# MISSOURI 2019 AIRPORT LIGHTING PACKAGE

## WEST PACKAGE

## ADDENDUM NO. 1

November 2, 2020

VAULT ENCLOSURE  
PLAN AND DETAILS

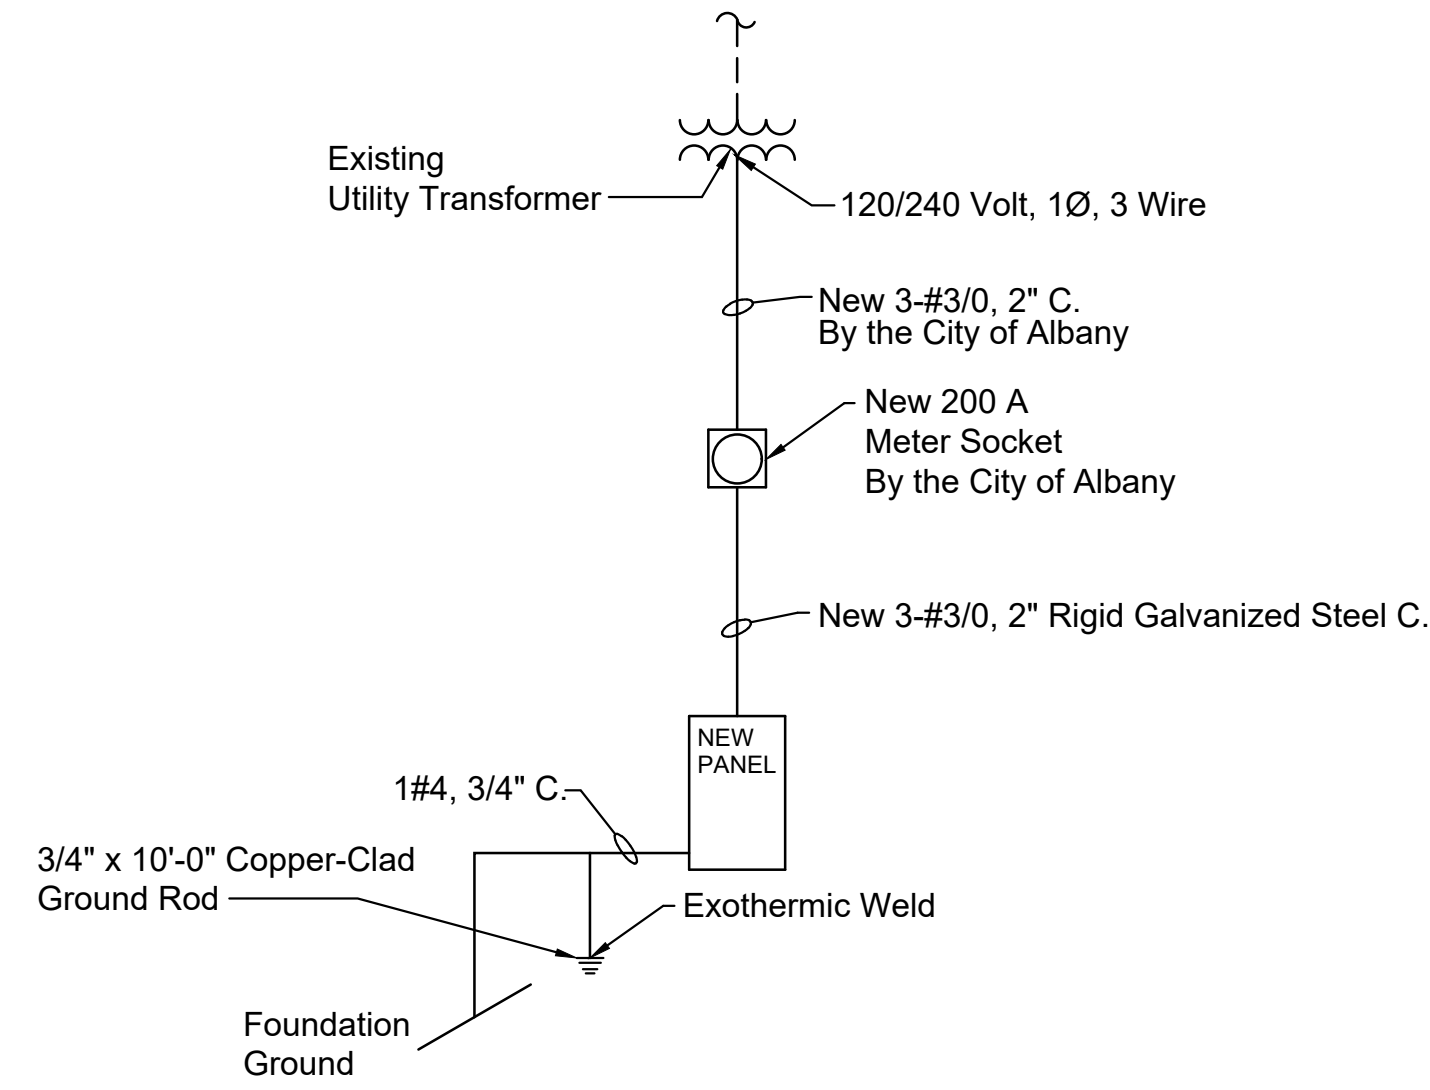
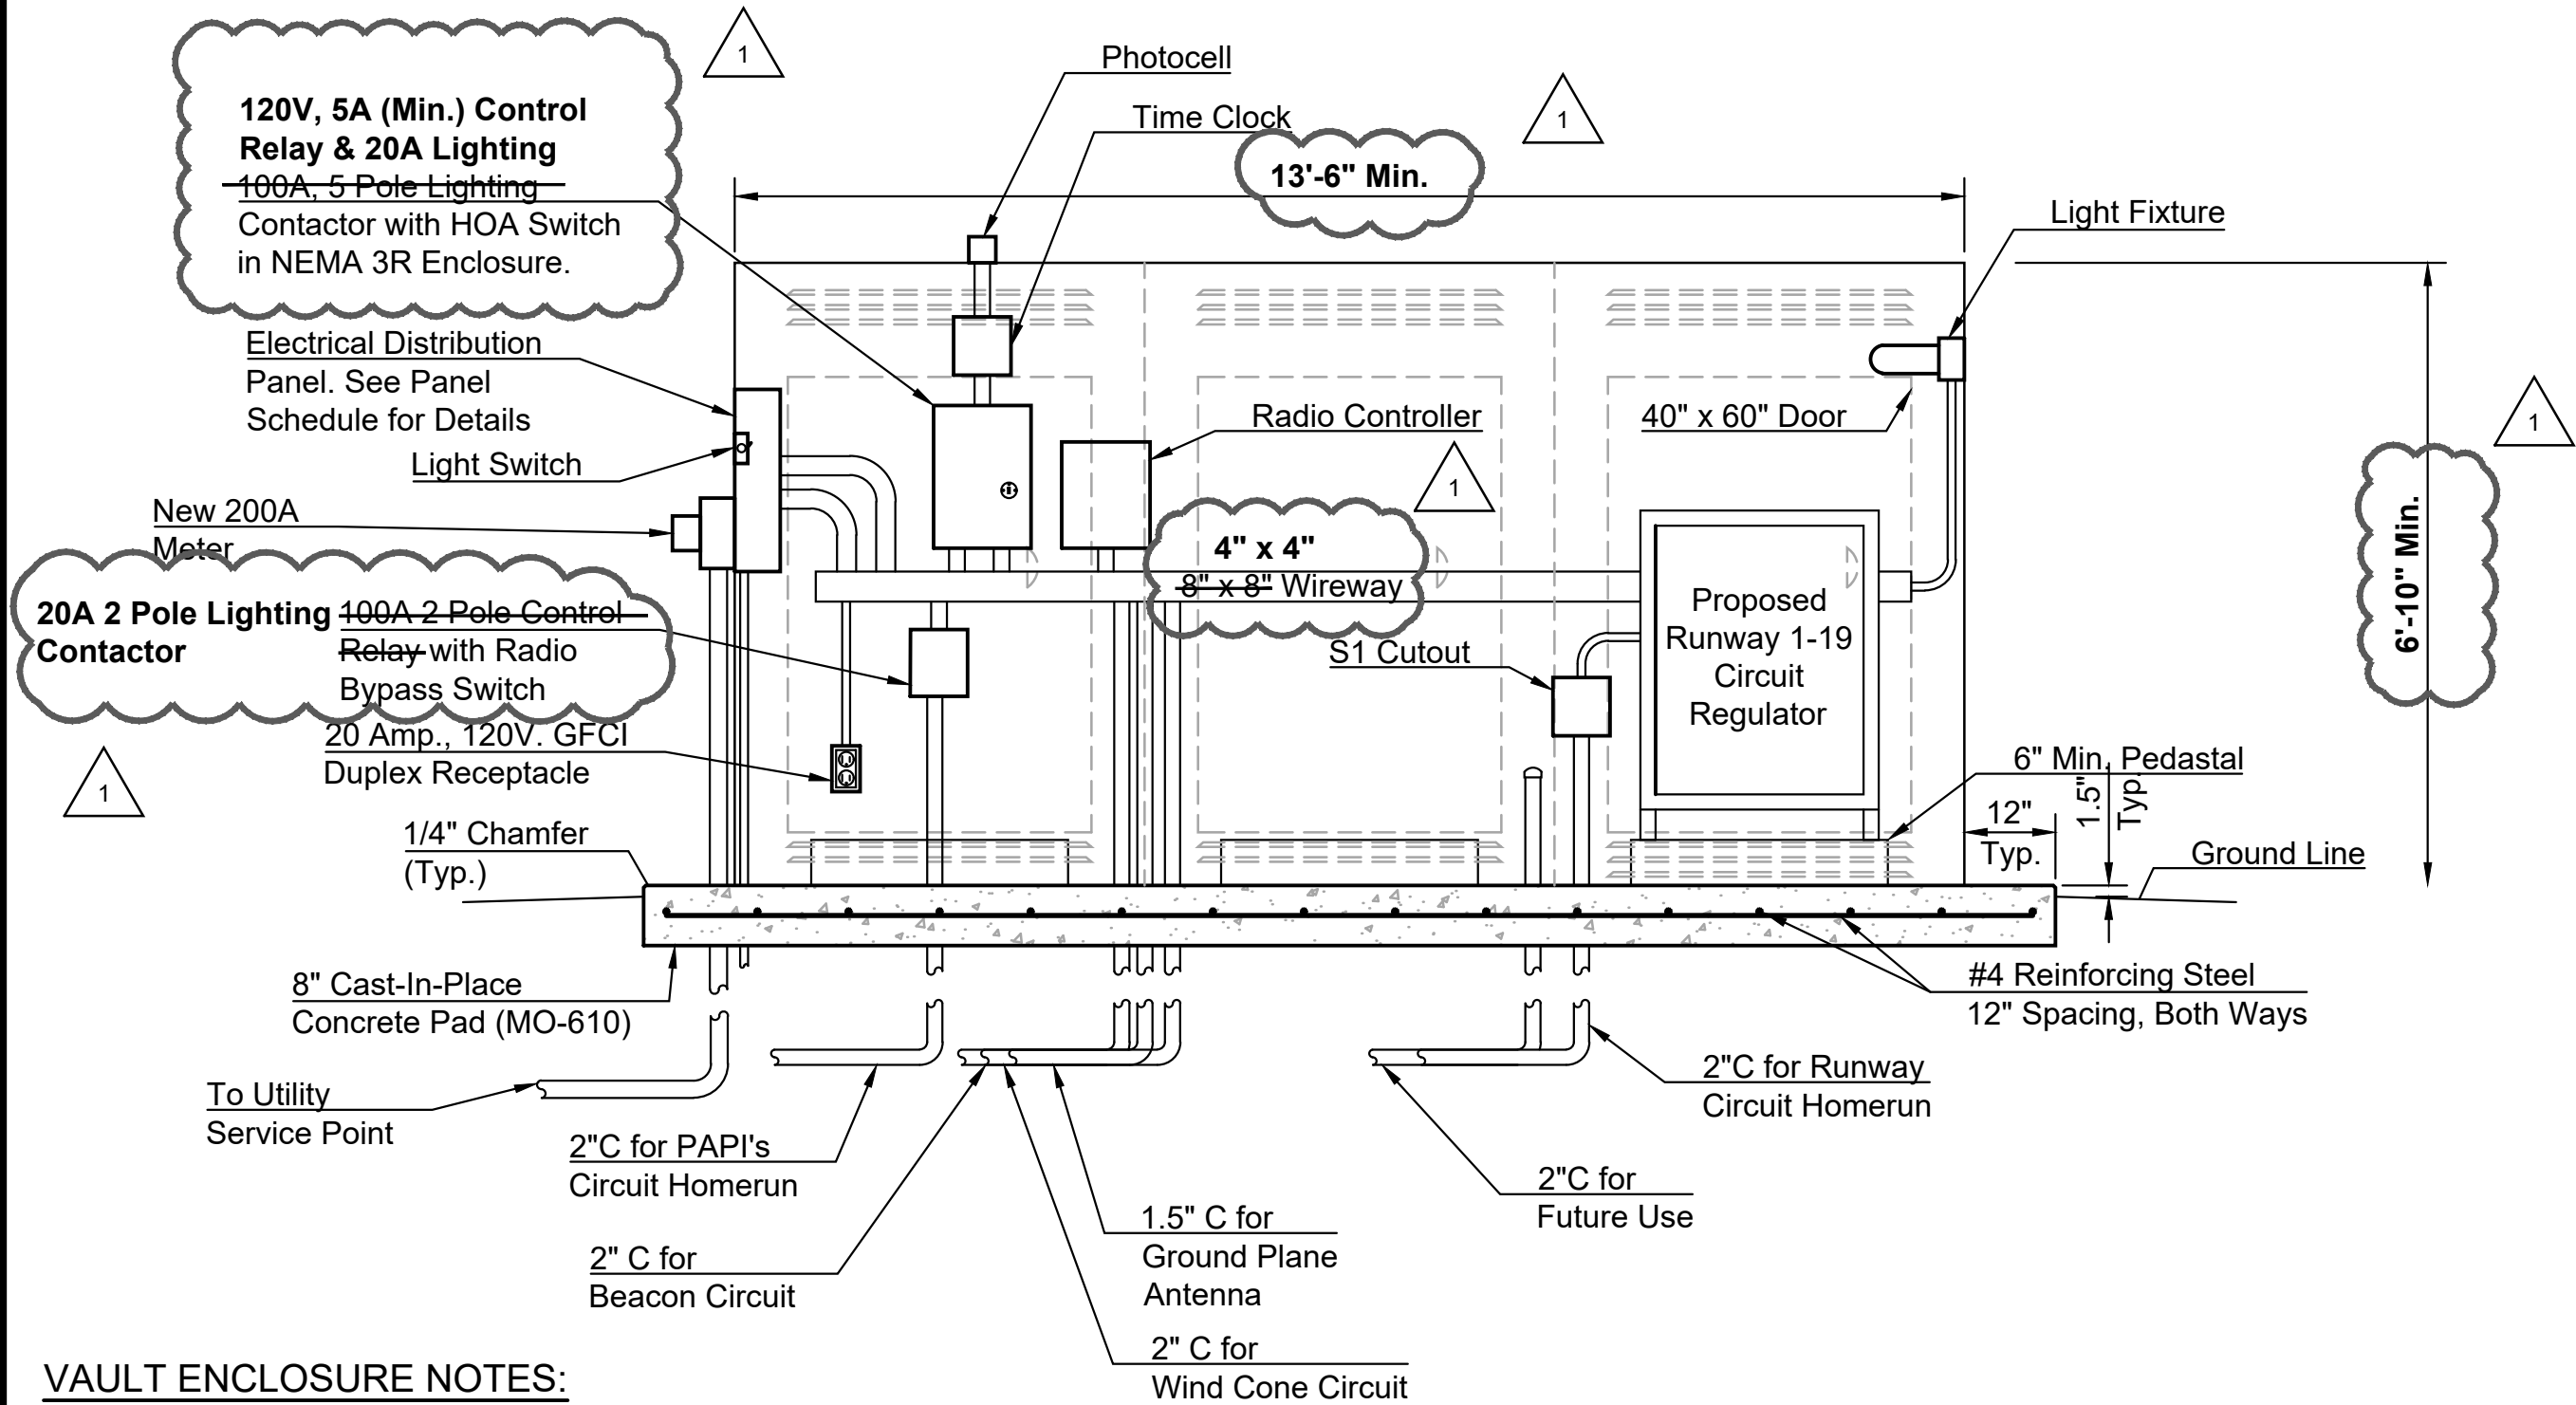
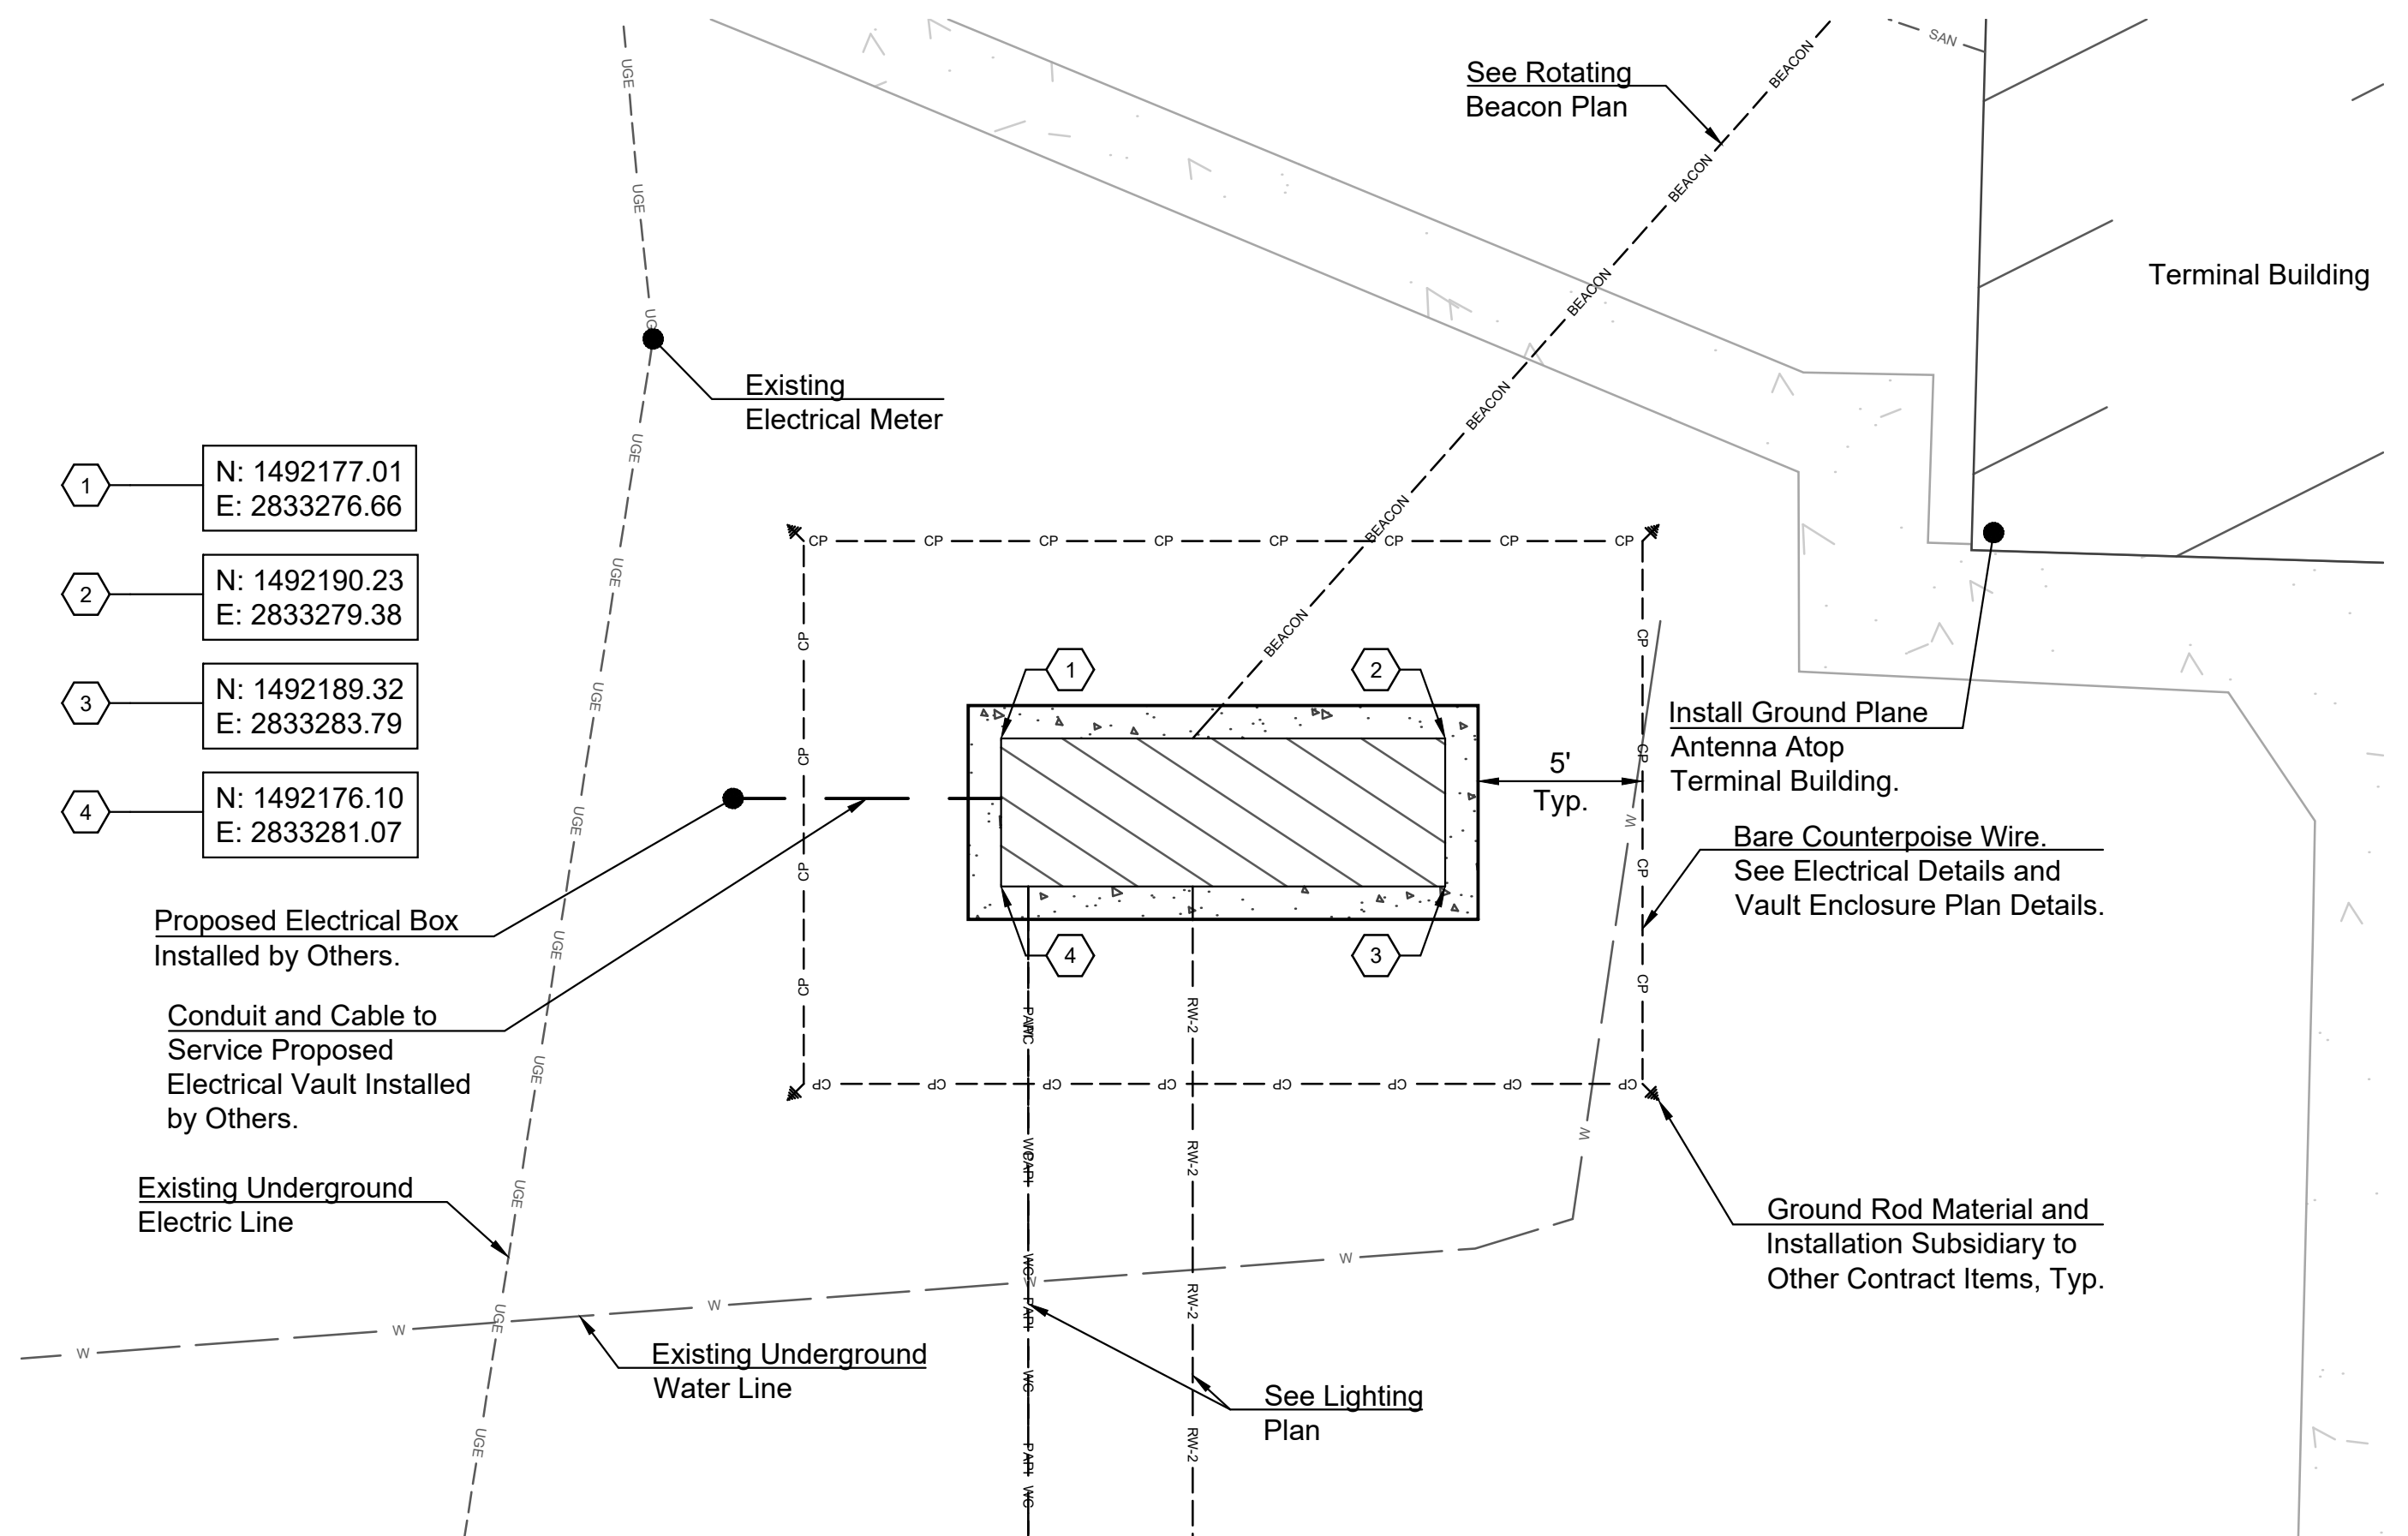
1. **Schedule A: Albany Municipal Airport**, Sheet No. 16 Vault Enclosure Plan and Details. The vault height (6’-10” minimum) and length (13’-6” minimum) were added to the vault enclosure elevation detail. The 8” x 8” wireway is now a 4” x 4” wireway. The 100A lighting contactor for the regulator, rotating beacon, and wind cone was removed. The regulator will now be controlled via a 120V, 5A (minimum) control relay and the rotating beacon and wind cone via a 20A, 2 pole lighting contactor. The PAPI control relay is now a 20A, 2 pole lighting contactor.
